UNITED STATES PATENT AND TRADEMARK OFFICE

APPLICATION NO.	FILING DATE	FIRST NAMED INVENTOR	ATTORNEY DOCKET NO.	CONFIRMATION NO.
10/708,879	03/30/2004	Bin Wei	129545-1	2878

Office Action Summary

DETAILED ACTION

FIG. 7(a)

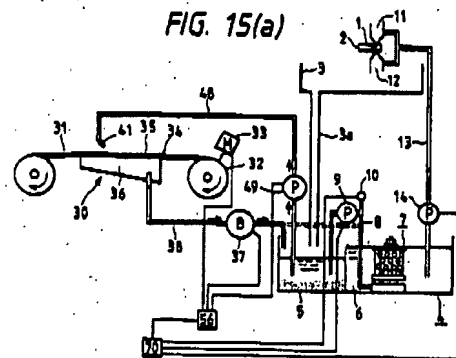
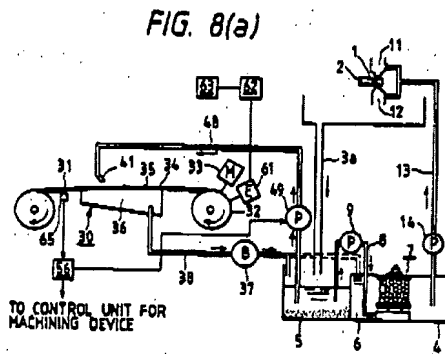
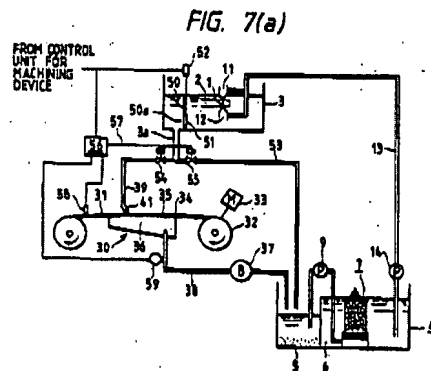
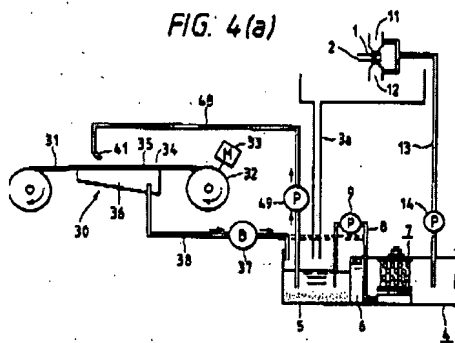
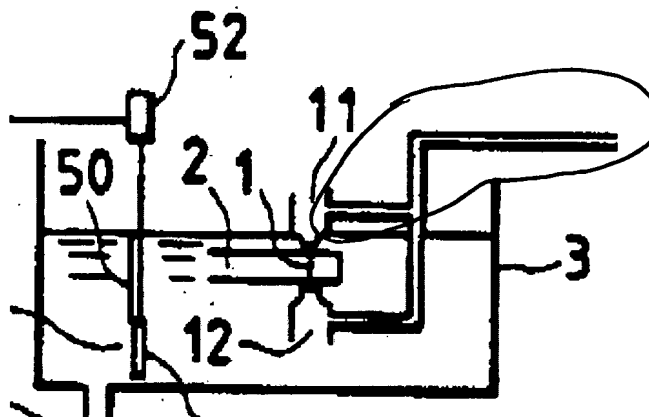
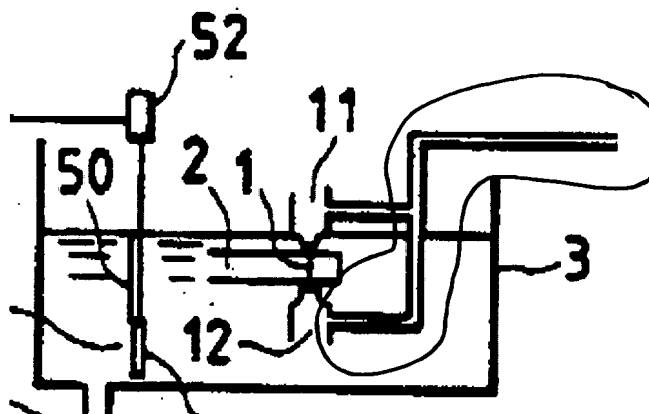
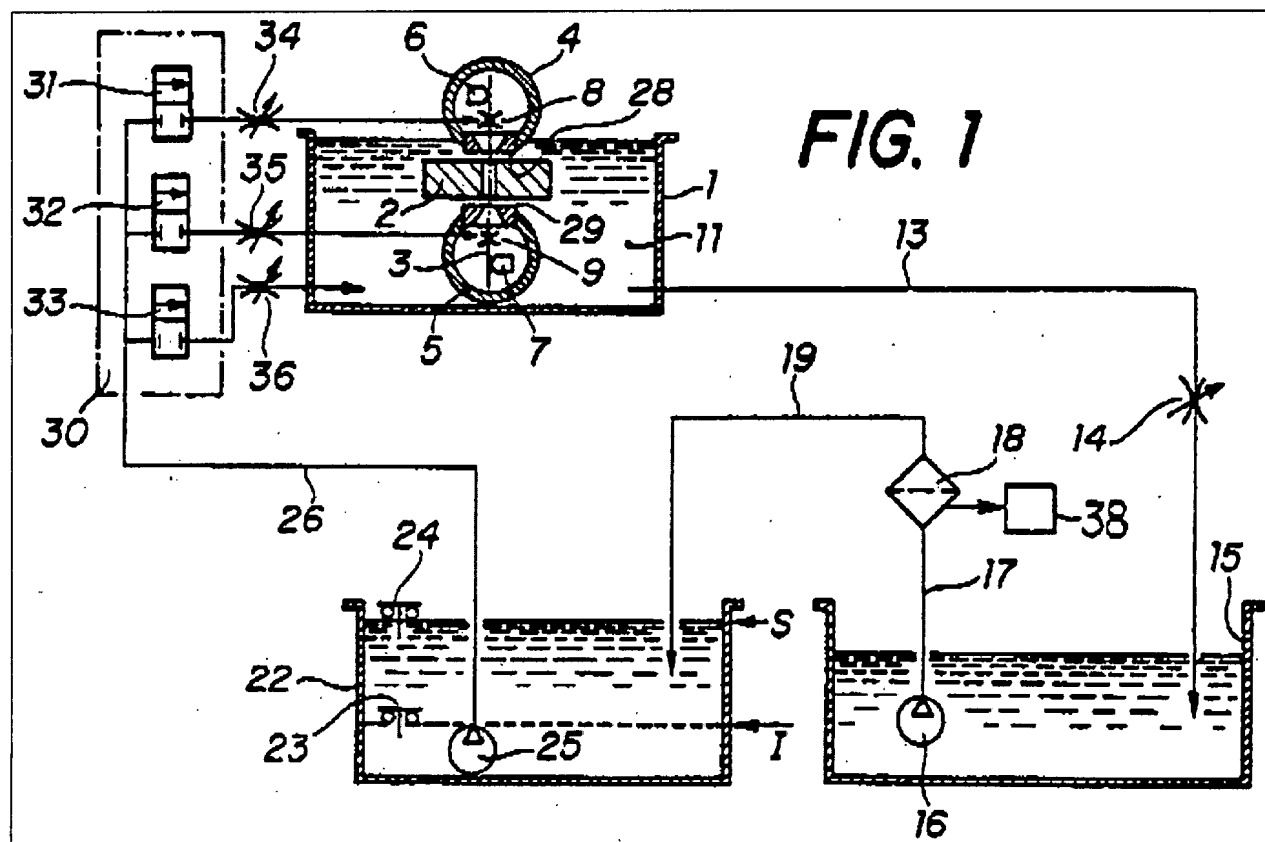
Claims 1,3-13 and 15-24 are rejected under 35 U.S.C. 103 as being obvious over the combined teachings of Suzuki (US 5,221,467) and Corcelle (US 5,071,567). See Figures 4(a), 7(a), 8(a) and 15(a) each of which illustrates two stage filtration in an EDM:

The claims essentially differ from Suzuki by specifying a liquid adding inlet *"directly connected to said work tank."* Corcelle discloses a return line directly connected to said work tank as depicted in Fig. 1 of Corcelle:
